**From:** [Mike Murray](#)  
**To:** [Sandra Hamilton](#)  
**Cc:** [Doug Wetmore](#); [Jami Hammond](#); [Britta Muiznieks](#); [Thayer Broili](#)  
**Subject:** Re: Fw: By-pass south of Ramp 44  
**Date:** 10/08/2010 06:19 AM  
**Attachments:** [Bypass & Ramp 44.pdf](#)

Subject Fw: By-pass south of Ramp 44

(FONSI, page 11, with edited text suggested for Preferred Alternative in FEIS)

Bypass & Ramp 44.pdf

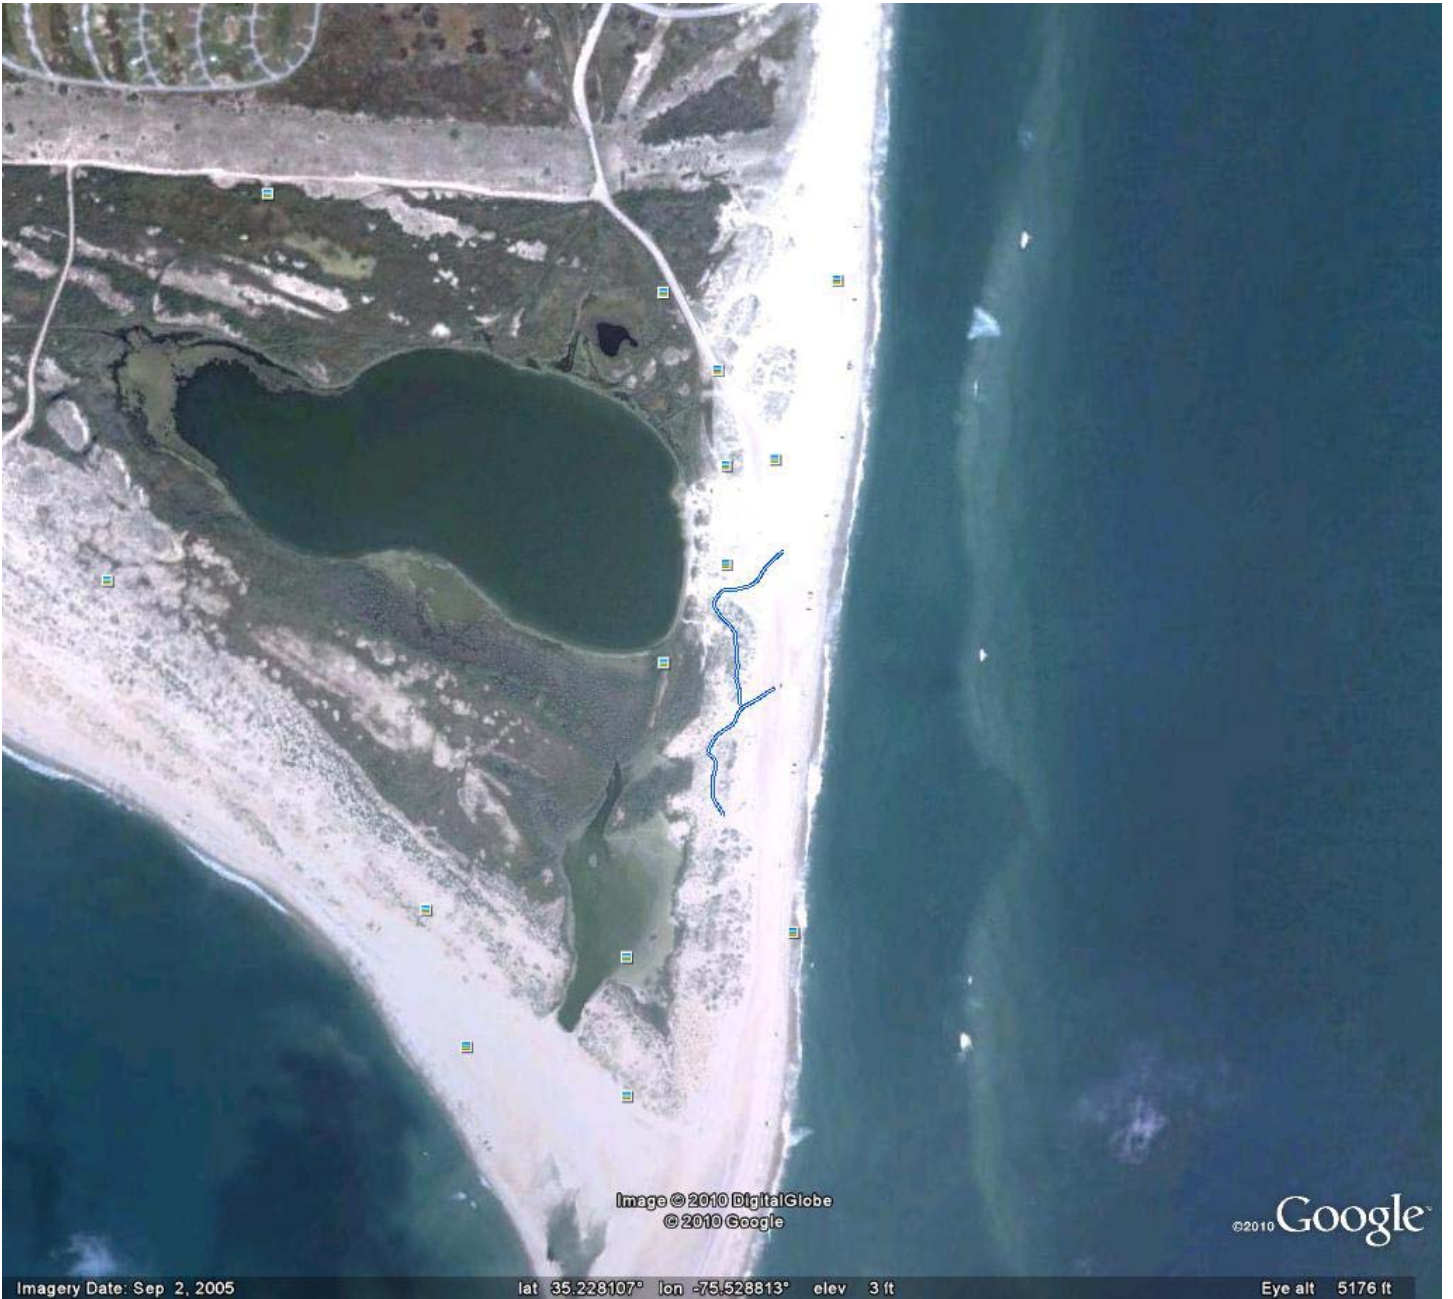
The longer possible bypass would add about 0.2 mi to the existing bypass (0.17 mi long), but there might be some wetland issues and more grading of dunal area would be needed. The shorter bypass option shown would only add about 0.1 mi to the existing bypass but would clear any wetland issues (as far as an untrained eye

can see) and would require much less grading and vegetation loss.

Anyhow, it doesn't seem like there is an "easy" quick fix (i.e. just posting a new route through the area) but may be possible with some help from heavy equipment.
